RE: SUBMISSION ON IVANHOE ESTATE MASTERPLAN (SSD 17_8707)

This submission on the Ivanhoe Estate Masterplan (SSD 17-8707) has been prepared by Robinson Urban Planning Pty Ltd (**RUP**) for China Overseas Sydney Pty Ltd (**COLI**) being the owner of 137-143 Herring Road at Macquarie Park which occupies the corner of Herring Road and Epping Road to the immediate north-west of the Ivanhoe Estate.

Figure 1: Mark-up of Master Envelope Control Plan (DA01.MP.100[3])

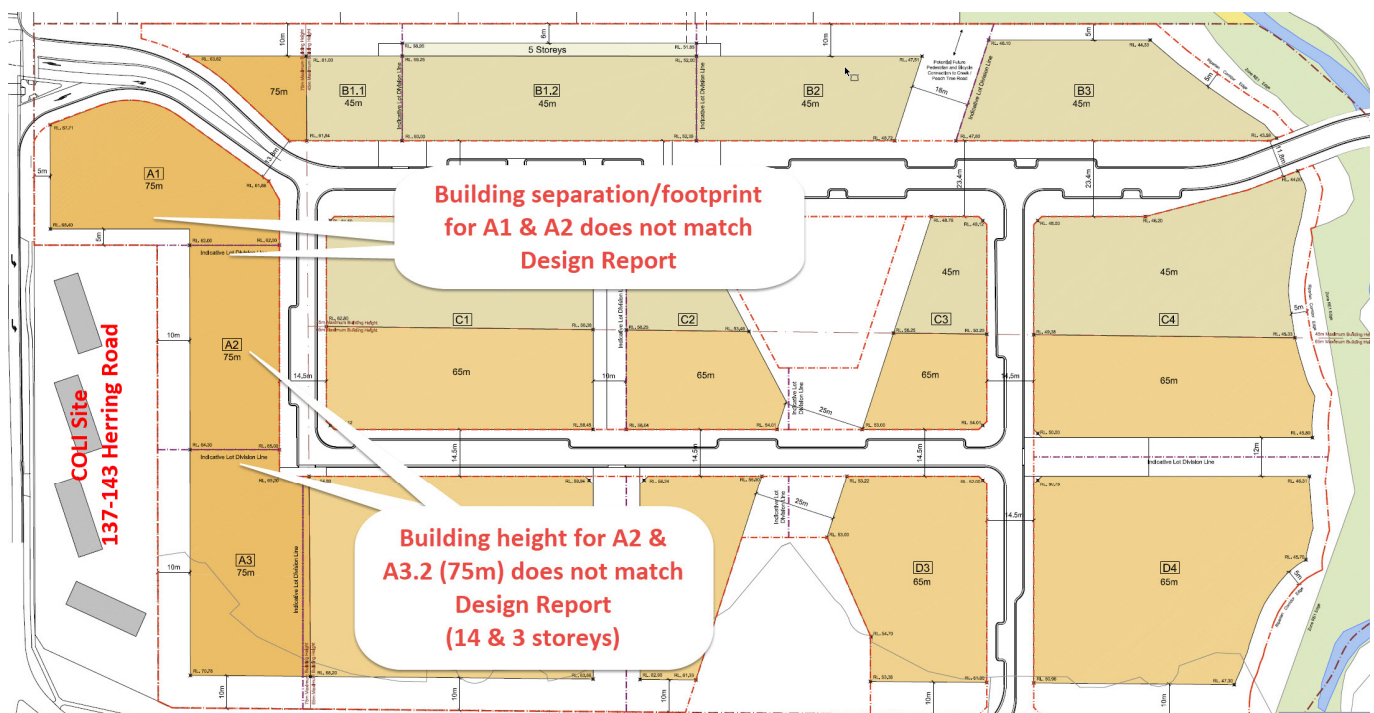
- b. There are very substantial differences between the Masterplan Drawing Set and the Indicative Reference Scheme. Adjoining the COLI Site, the following critical discrepancies are of considerable import for COLI (see our mark-up of the Master Plan Envelope Control Plan, Design Report Photomontage, Design Report Site Plan and Section 06 at **Figures 1 to 4**):

- Height
 - i. Master Envelope Control Plan (DA01.MP.100[3]) shows a consistent building height of 75m for Buildings A1, A2 and A3 (equal to 24 storeys), simply applying the Ryde Local Environmental Plan 2014 (**RLEP 2014**) height standard without responding to the site circumstances.

- iii. It is not reasonable for the applicant to seek the degree of height flexibility being sought in the Masterplan.
 - Building separation
 - i. Master Envelope Control Plan (DA01.MP.100[3]) no building separation between Buildings A1/A2 and A2/A3.

- Building articulation
 - i. Master Envelope Control Plan (DA01.MP.100[3]) shows no building articulation.
 - ii. In contrast, the Indicative Reference Scheme described in the Design Report illustrates and articulated and stepped buildings.

- iii. It is not reasonable for the applicant to seek the degree of building envelope flexibility being sought in the Master Plan.
 - Land use
 - i. Master Envelope Control Plan (DA01.MP.100[3]) does not show the distribution of land uses.

- a. Adjoining the COLI site, the Masterplan Envelope Control Plan (DA01.MP.100[3]) proposes:
 - 10m setback to the north-western (longer) side boundary, whereas the ADG requires a setback of up to 12m for the proposed 75m A2 and A3 building envelopes

- 5m setback to the western (shorter) side boundary, where the ADG would require a setback of up to 12m for the proposed 75m A1 building envelope.
- b. Adjoining existing apartments on Peach Tree Road, the Masterplan Envelope Control Plan (DA01.MP.100[3]) proposes:

Recommendation 1: The Masterplan Drawing Set and EIS should be amended and expanded to address the issues raised above. In particular, the Masterplan Drawing must be amended to more closely reflect the Indicative Reference Design. If this recommendation is not adopted, the EIS and Design Report must be amended to fully assess the environmental impacts of the Masterplan Envelope Control Plan.

Recommendation 3: The Masterplan Drawing Set should be amended to provide side boundary setbacks that comply with the ADG Objectives 2F and 3F.

Figure 2: Mark-up of Design Report Photomontage

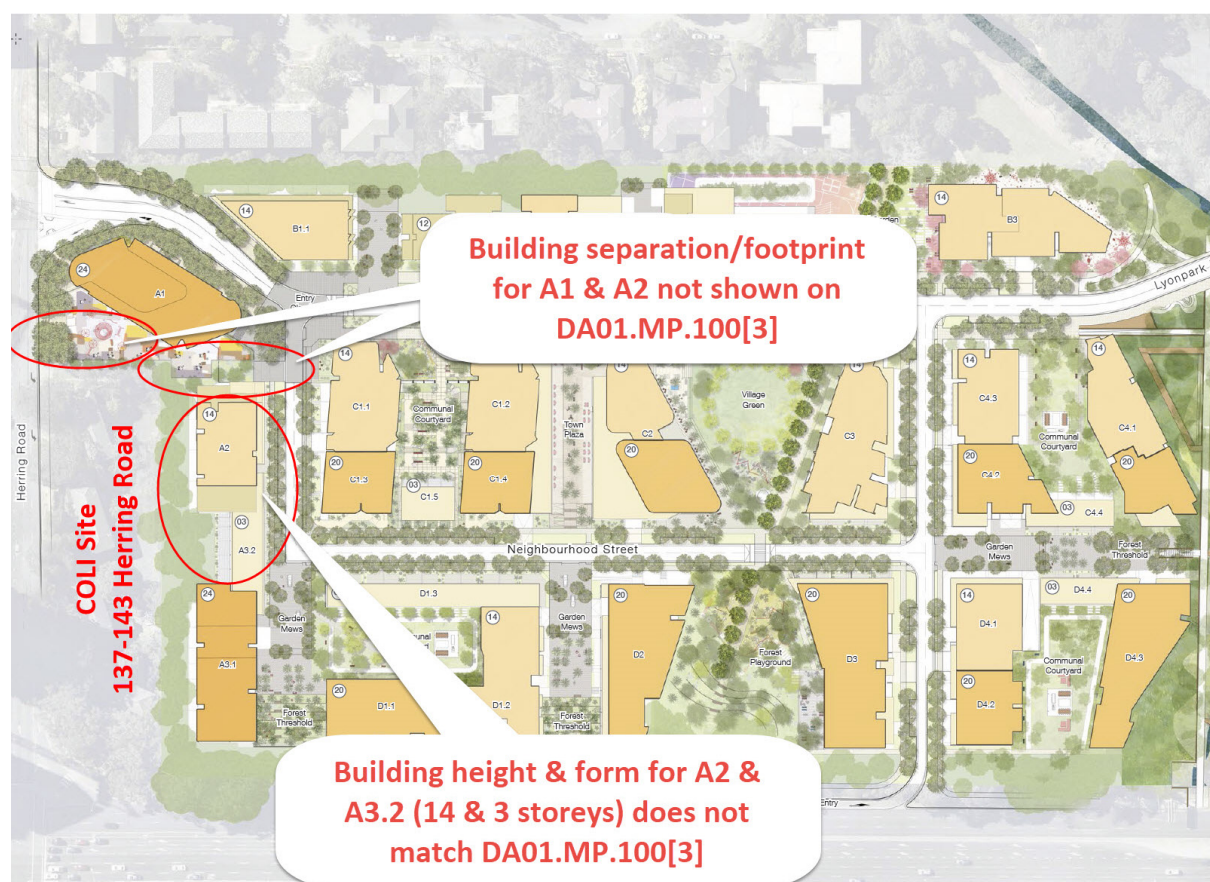
- ii. In contrast, the Indicative Reference Scheme described in the Design Report illustrates and assesses 14 storey and 3 storey elements at A2 and A3.2 (respectively).

- ii. In contrast, the Indicative Reference Scheme described in the Design Report illustrates and assesses buildings with considerable separations.
 - iii. It is not reasonable for the applicant to seek the degree of building separation flexibility being sought in the Master Plan.
